Technical Service Bulletin

37 Transmission malfunction, DTC P17F600, U008000, and/or U010100 stored in the TCM or ECM

37 19 88 2053878/4 August 14, 2019. Supersedes Technical Service Bulletin Group 37 number 19-86 dated March 21, 2019 for reasons listed below.

Model(s)	Year	VIN Range	Vehicle-Specific Equipment
A6, A7	2019	000001 - 121296	3.0TFSI

Figure 5. Routing and wrapping of the aft part of the transmission harness.

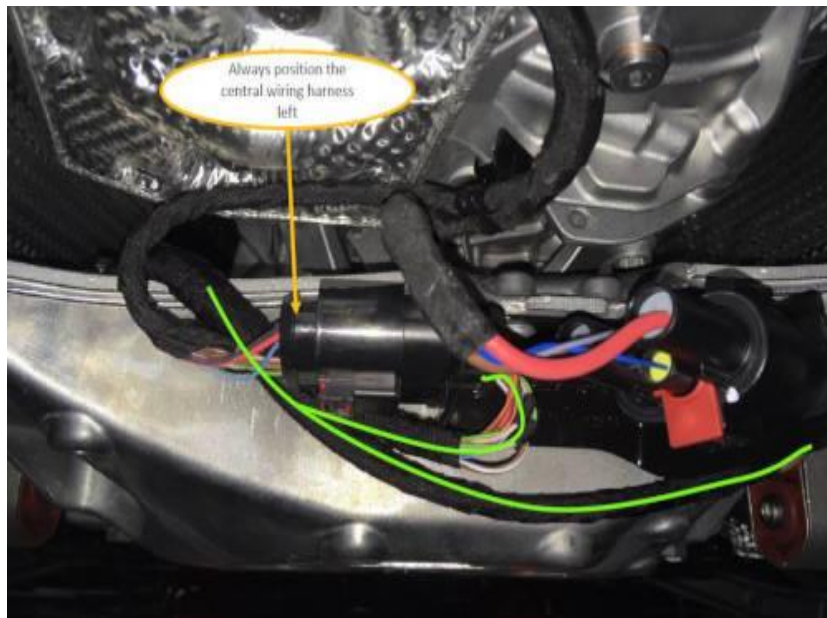
2. Replace the transmission harness with a new part and reroute the transmission harness. The transmission harness should not be repaired.
 - Remove the old transmission harness in the vehicle.
 - Wrap the exposed wires on the new transmission harness as shown in Figure 5.
 - Mount and route the new transmission harness as shown in Figure 6.
